## Meeting Agenda Plat Committee

Monday, October 11, 2021

1. [KPB-3597](#) Alaskan Wildwood Phase 2  
KPB File 2021-127  
*Attachments:* [1. MAP Vicinity](#)  
[2. MAP Aerial Map Zoomed In](#)  
[3. Plat Prelim KPB 2021-127 Reduced](#)  
[4. Staff Report Alaskan Wildwood Phase 2 KPB 2021-127](#)  
[5. MAP Aerial 3](#)  
[6. MAP Aerial Map Zoomed Out](#)  
[7. MAP Contour](#)  
[8. MAP Section Line Easement](#)  
[9. MAP Wetlands](#)  
[10. Plat Parent HM 2000-48](#)  
[11. Plat Parent HM 2000-31](#)
2. [KPB-3598](#) ASLS No. 2017-23 Tract A B C D & E  
KPB File 2021-133  
*Attachments:* [1. MAP Vicinity](#)  
[2. MAP Aerial](#)  
[3. Plat Prelim KPB 2021-133 Reduced](#)  
[4. Staff Report ASLS 2017-23 Tracts A-E 2021-133](#)  
[5. Plat Parent SW2001-10](#)  
[6. Plat parent SW 1998-03](#)

SHEET: 3 OF 6

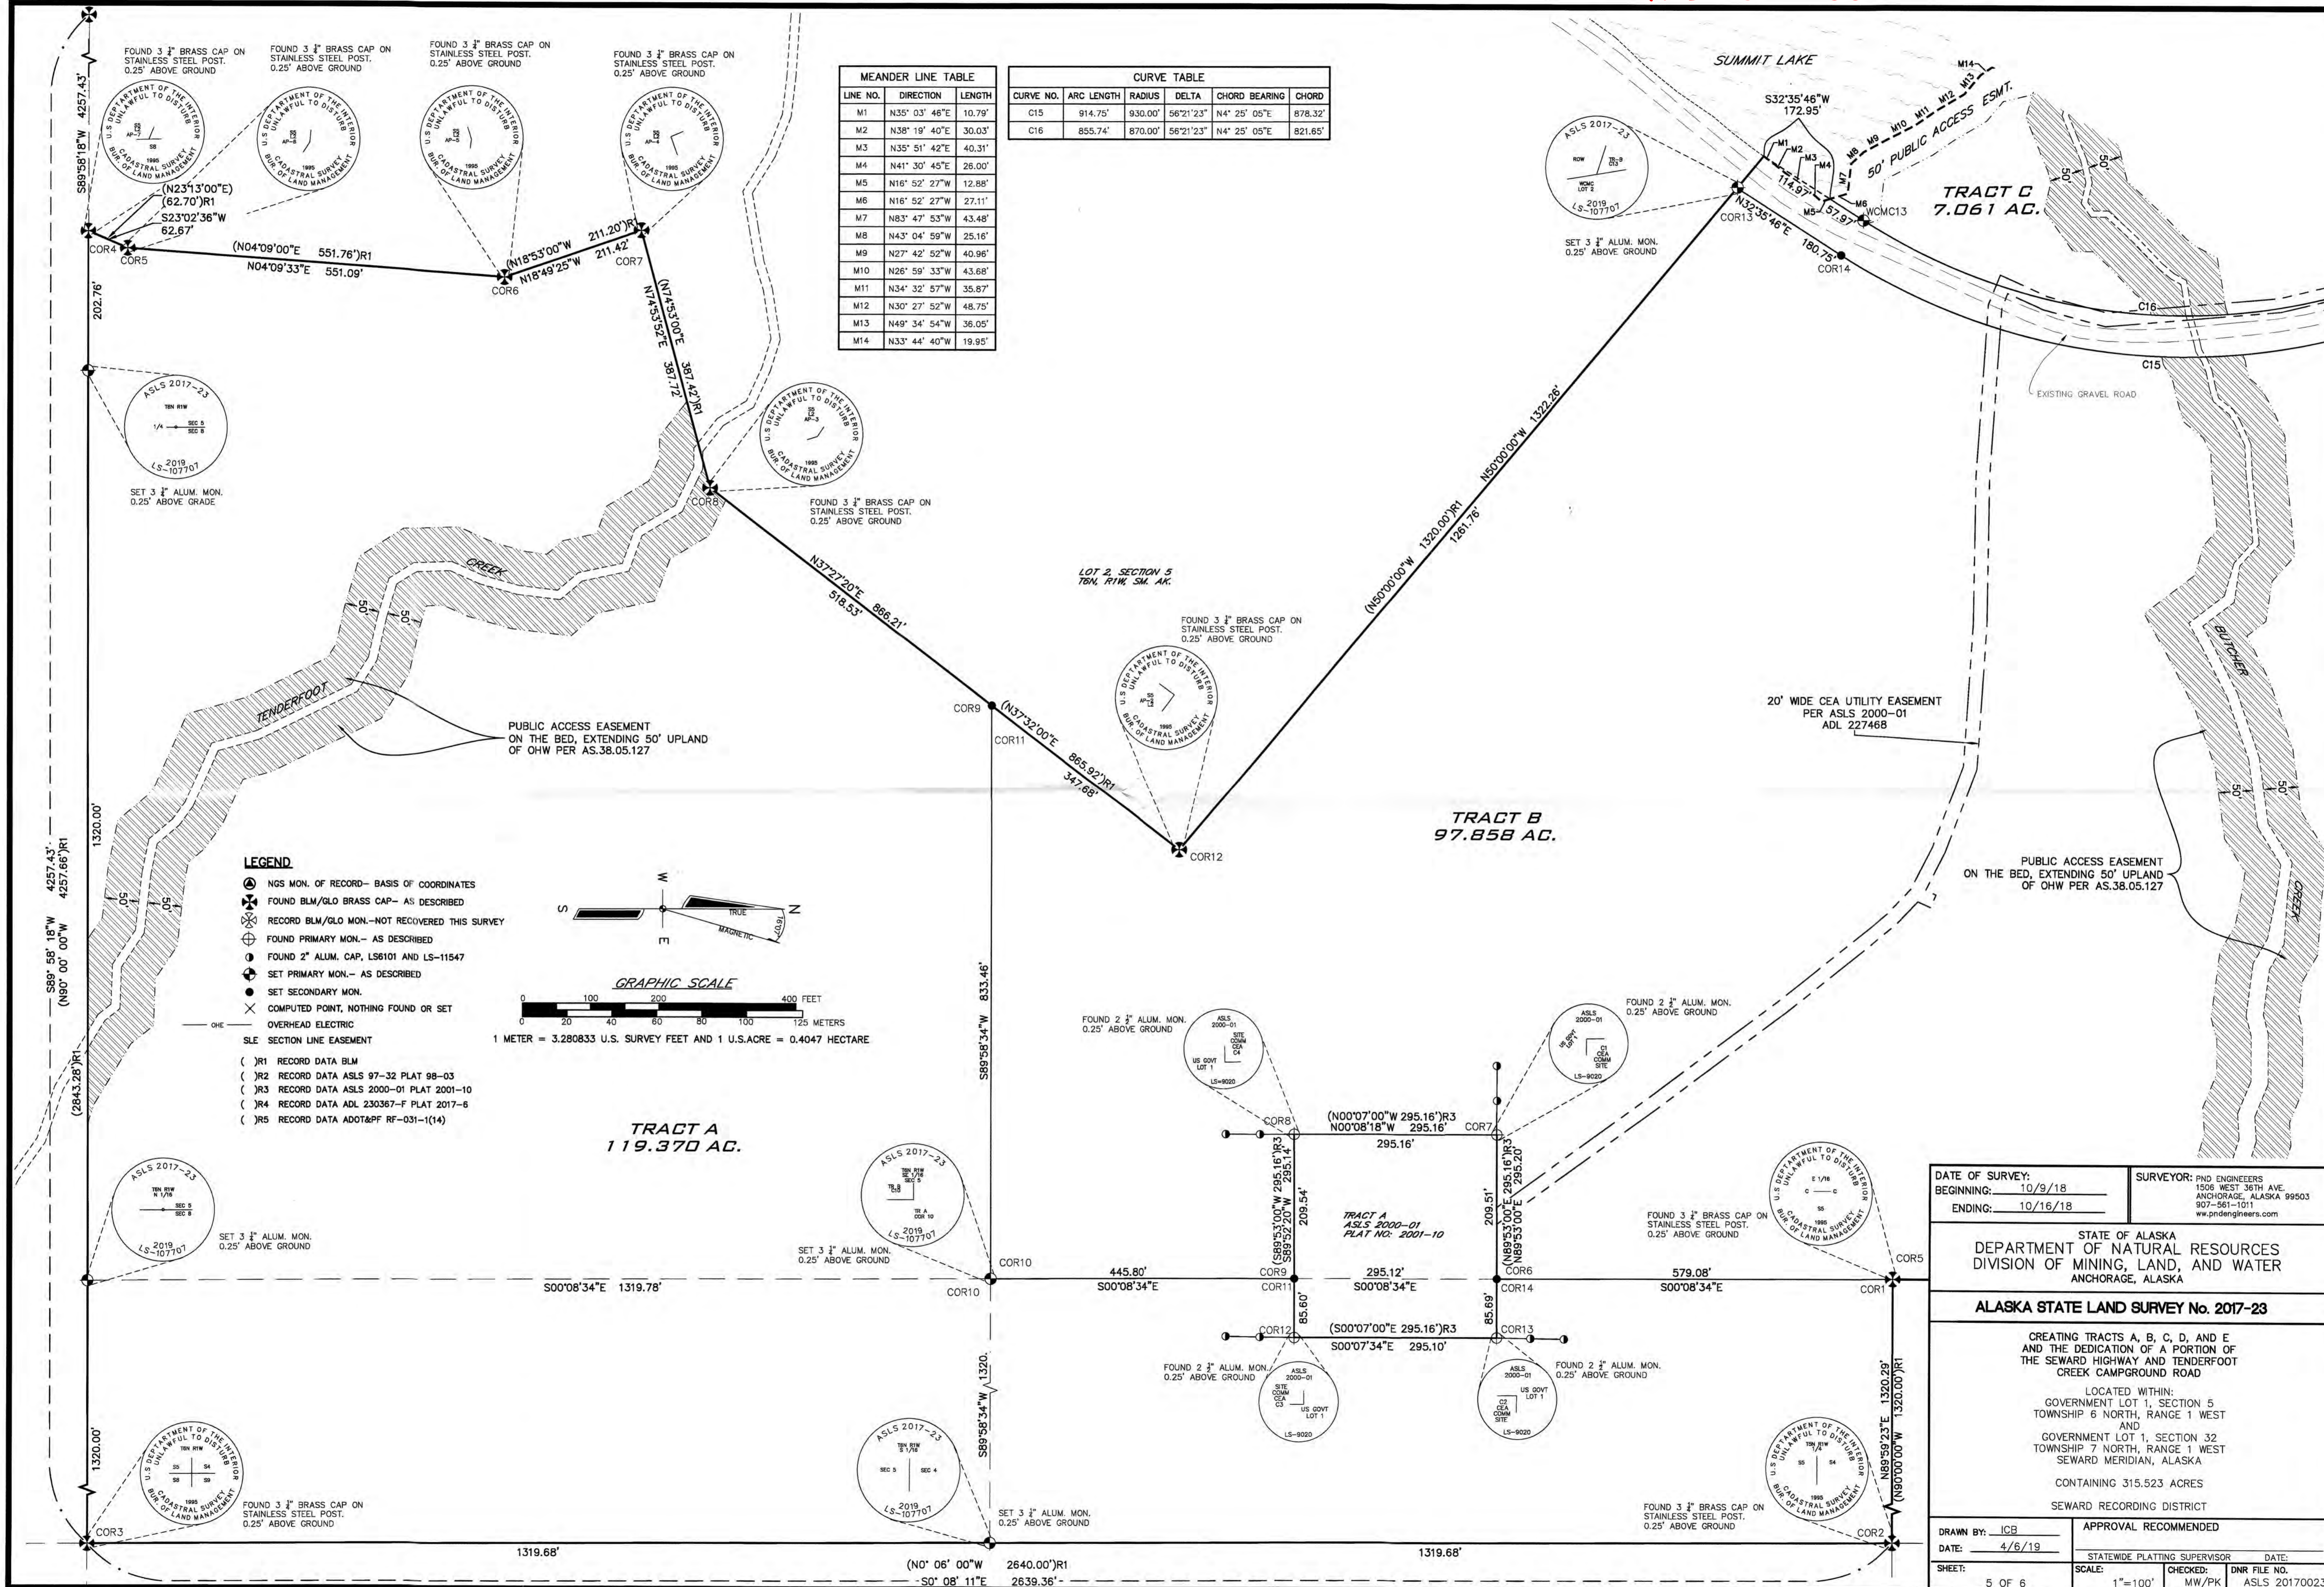
*Sheet 1 – Add a plat note that the subdivision is within the Chugach National Forest Boundary.*

*Sheet 4 – Neighboring Tract B of ASLS 97-32 is shown with a 50 foot public access easement along Summit Lake all the way to Tenderfoot Lane. Per the ASLS 97-32, the easement ends at the meander point between S 44° 36' 10" W and S 34° 50' 05" W. Revise the depiction or provide documentation that the public access easement is for the full length of Tract B.*

*Sheet 5 – Depict and label the 50 foot section line easement located along the east and southern boundary of proposed Tract A.*
